## Dear Planning Inspectorate,

Sizewell C – Safety, capability and capacity, environmental health and funding – a 2020 perspective.

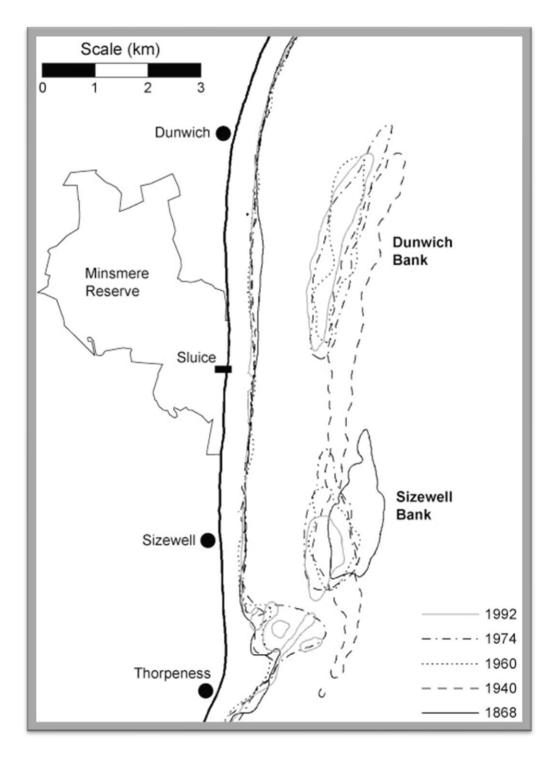
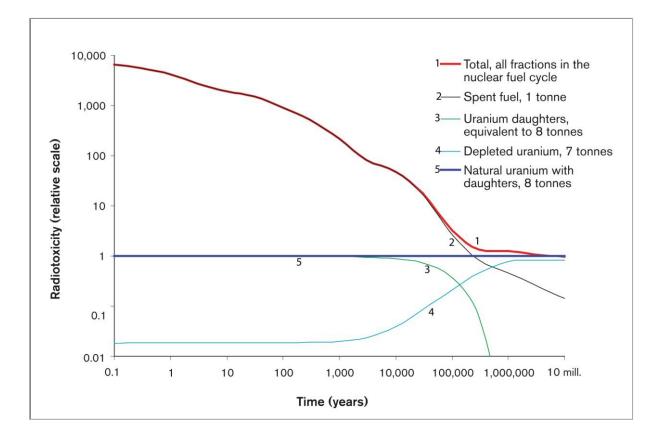
A historical hydrographical survey chart in Appendix 1, however, shows that offshore banks are not stable over the longer term. The map outlines changes in the position and shape of the Sizewell-Dunwich Banks between 1868 and 1992. *See Appendix 1 or PYE, K. and BLOTT, S.J., 2006. Coastal processes and morphological change in the Dunwich-Sizewell area, Suffolk, p466.*

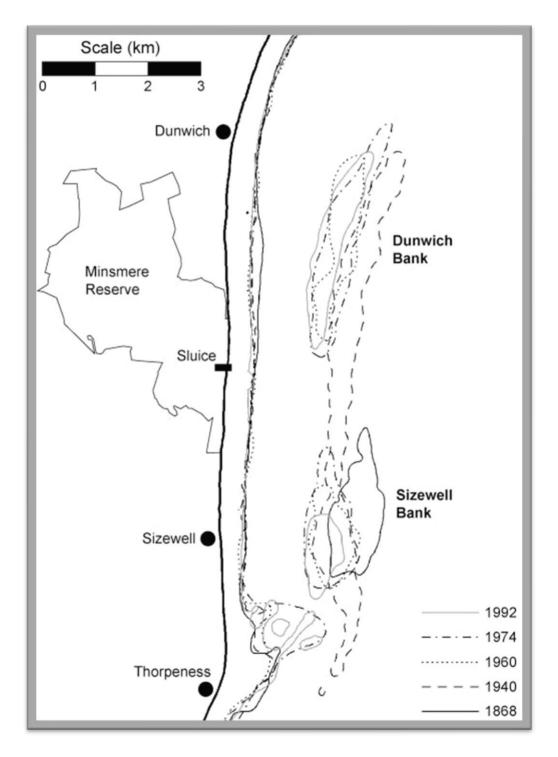
A historical hydrographical survey chart in Appendix 1, however, shows that offshore banks are not stable over the longer term. The map outlines changes in the position and shape of the Sizewell-Dunwich Banks between 1868 and 1992. *See Appendix 1 or PYE, K. and BLOTT, S.J., 2006. Coastal processes and morphological change in the Dunwich-Sizewell area, Suffolk, p466.*
